| 7. Lease Name or Unit Agreement Name<br><b>OUTER BANKS SWD</b>                           |

**Mesquite SWD, Inc. requests permission for the following changes to the well plan approved in SWD-1641:**

**Applicant:** Mesquite SWD, Inc. **OGRID Number:** 161968  
**Well Name:** Outer Banks SWD No. 1 **API:** 30-015-43868  
**Pool:** SWD; Devonian **Pool Code:** 96101

Re: Application to Amend Order SWD-1641  
Mesquite SWD, Inc.  
Outer Banks SWD Well No. 1  
API No. 30-015-43868  
1990' FSL & 955' FEL, Unit I  
Section 13, T-20S, R-29E, NMPM,  
Eddy County, New Mexico

**Exhibit No. 3**  
**Original Wellbore Configuration**  
**Application to Amend SWD-1641**  
**Outer Banks SWD No. 1**

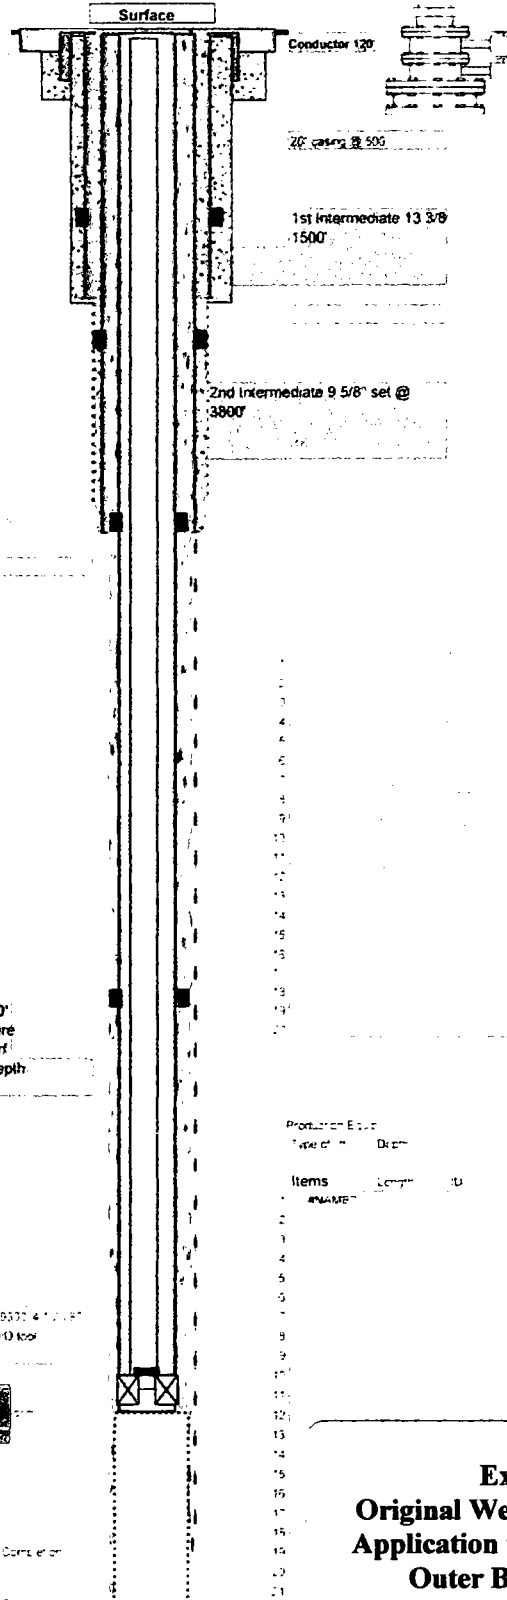
3. Attached is the wellbore schematic originally submitted with the C-108 application received by the Division on June 9, 2016 (Exhibit 3). Also attached is a wellbore schematic that shows the proposed wellbore configuration (Exhibit 4). In addition to the request to amend the tubing size, Mesquite also proposes to make the following changes to the casing program. These changes are highlighted on the attached wellbore schematic and on the BLM and OCD Sundry Notices attached:

|                      | <b><u>Original Casing</u></b>              | <b><u>Proposed Casing</u></b>              |
| Surface:             | 20" 106.5 J-55 LTC                         | 20" 94# K-55 BTC                           |
| 2 <sup>nd</sup> Int. | 9 5/8" 53.5# L-80 LTC                      | 9 5/8" 40" L-80 LTC                        |
| Production:          | 8 1/2" Hole; 7" 35# HCL80/<br>29# P110 LTC | 8 3/4" Hole; 7 5/8" 39#<br>P-110 FJ Casing |
| Open Hole:           | 5 7/8" Hole 13,180'-14,180'                | 6 1/2" Hole 13,180'-14,180'                |

**Mesquite SWD, Inc.**  
**Outer Banks SWD No. 1: Proposed Wellbore Schematic**  
**1990' FSL & 955' FEL (Unit I)**  
**Section 13, T-20S, R-29E, NMPM, Eddy County, NM**

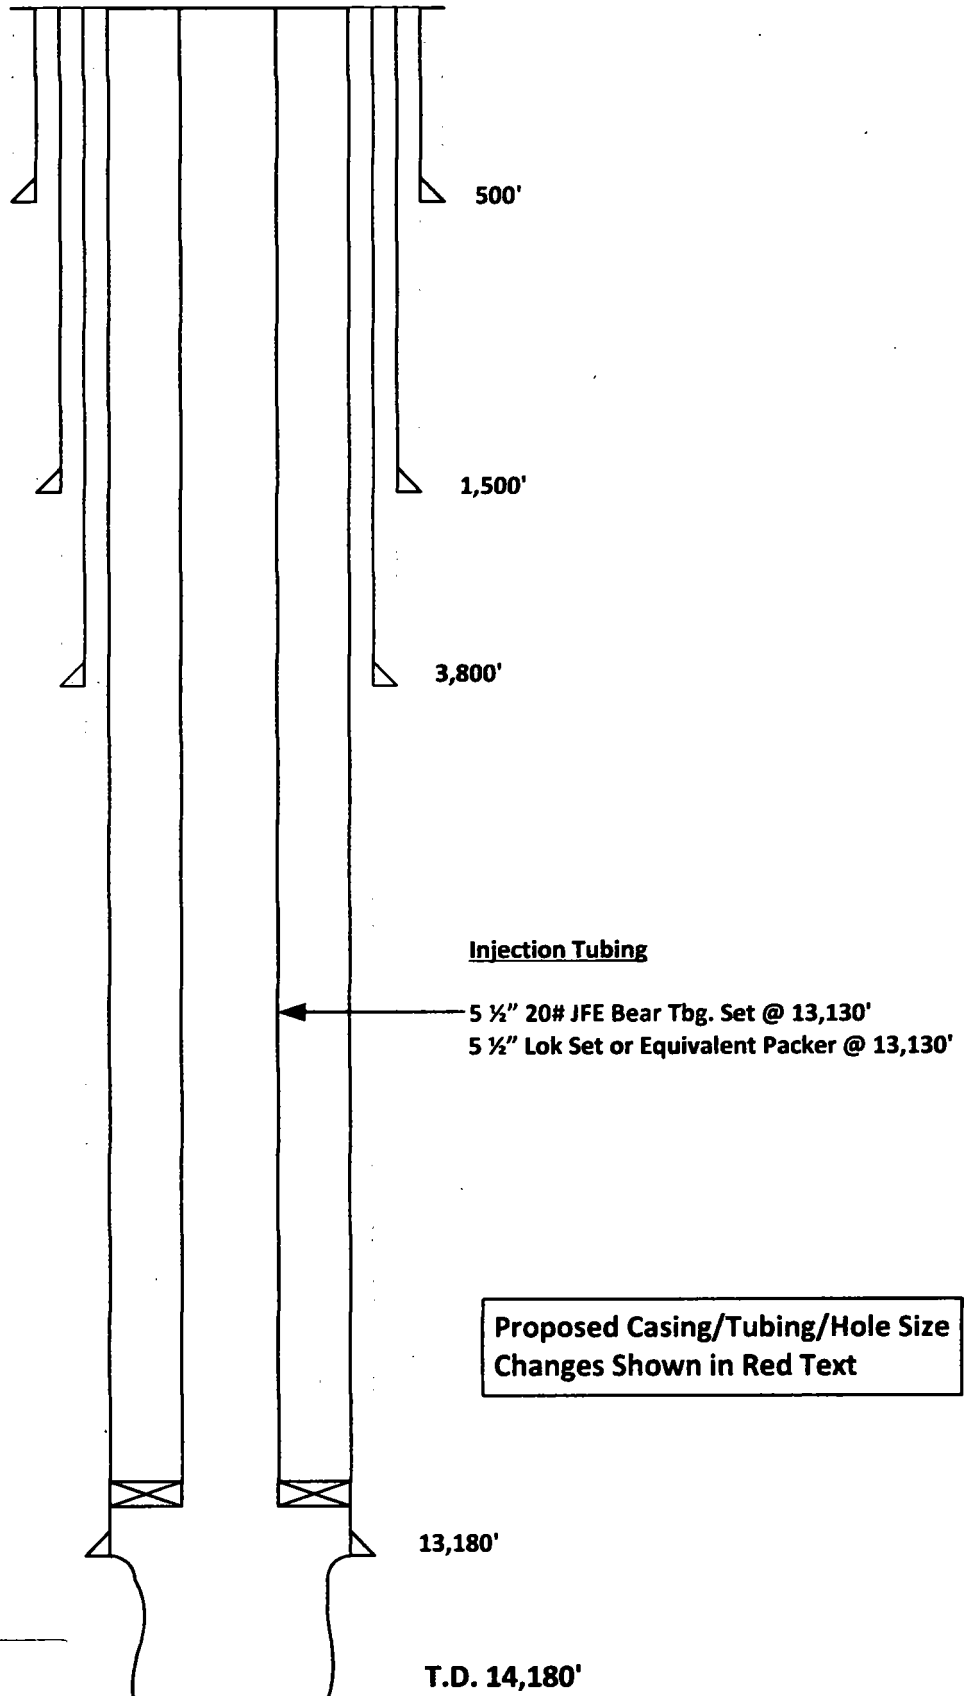
**Surface Casing:** Approved: 20" 106.5# J55 LTC  
Change to: 20" 94# K55 BTC, Burst SF 4.6; Collapse SF 1.29; Joint SF 15 Dry; Body SF 15 Dry

**2nd Intermediate Casing:** Approved: 9 5/8" 53.5# L80 LTC  
Change to: 9 5/8" 40# L80 LTC, Burst SF 1.2; Collapse SF 1.125; Joint SF 3.29 Dry; Body SF 3.4 Dry

**Production Casing:** Approved: 8 1/2" hole - 7" 35# HCL80/29# P110 LTC casing  
Change to: 8 3/4" hole - 7 5/8" 39# P110 FJ casing, Burst SF 1.27; Collapse SF 1.23; Joint SF 4.01 Buoy; Body SF 5.35 Buoy

**Open Hole:** Approved: 5 7/8" 13180' - 14180'  
Change to: 6 1/2" 13180' - 14180'

**Tubing:** Approved: 4 1/2" 11.6# P110 LTC  
Change to: 5 1/2" 20# JFE Bear

Revised proposed well bore diagram is attached.

Hole Size: 26"  
Size: 20" 94# K-55 BTC  
Set @: 500'  
Sx. Cmt: 874  
TOC: Surface

Hole Size: 17.5"  
Size: 13.375" 68# J-55  
Set @: 1,500'  
Sx. Cmt: 1117  
TOC: Surface

Hole Size: 12.25"  
Size: 9.625 40# L-80 LTC  
Set @: 3,800'  
Sx. Cmt: 753  
TOC: Surface

Hole Size: 8.75"  
Size: 7.625" 39# P-110 FJ  
Set @: 13,180'  
Sx. Cmt: 1092 2-Stage  
Stage Tools: 9,500' & 5,500'  
TOC: Surface

Hole Size: 6 1/2"  
Interval: 13,180'-14,180'

## Wellbore Hydraulics Models predict a 33% increase in maximum injection rate between 5.5x4.5 tubing and 7x5.5 tubing.

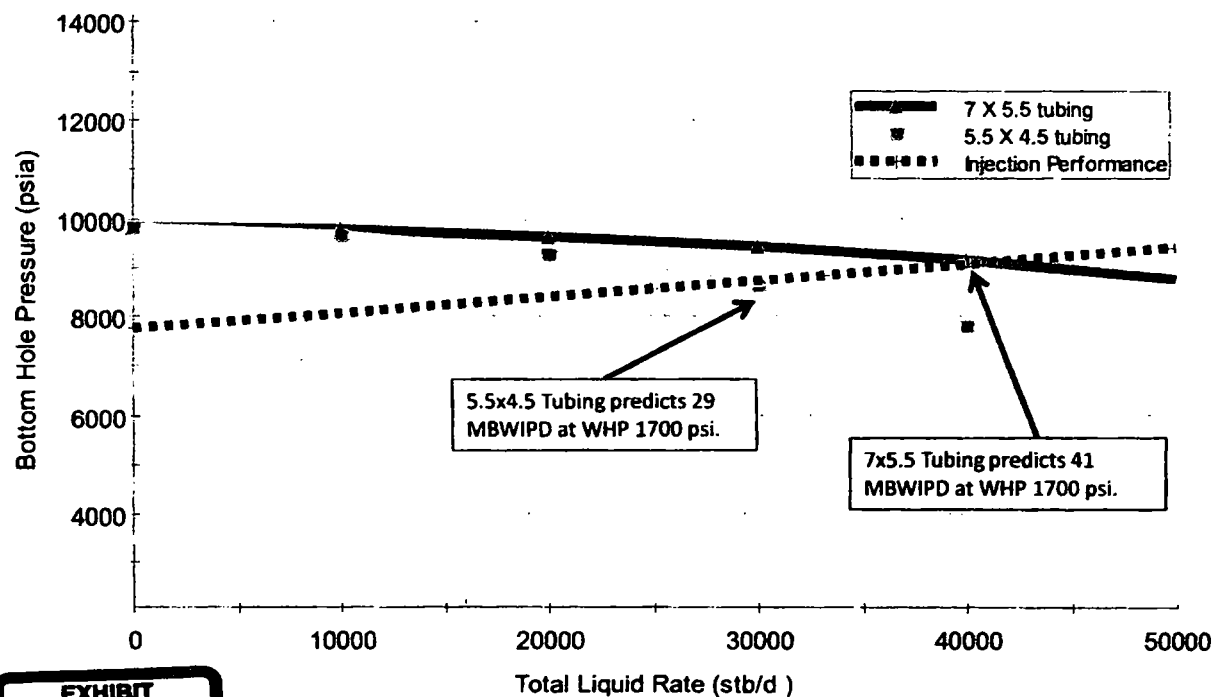
8. Attached is a document presented in Case No. 16308 which demonstrates that increasing the tubing size in a Devonian well in this area will result in an increase in injection rate from 29 MBWPD to 41 MBWPD (Exhibit 8). The resulting increase in injection rate will mean that less produced water disposal wells will be necessary to accommodate the ever-increasing demand for disposal.
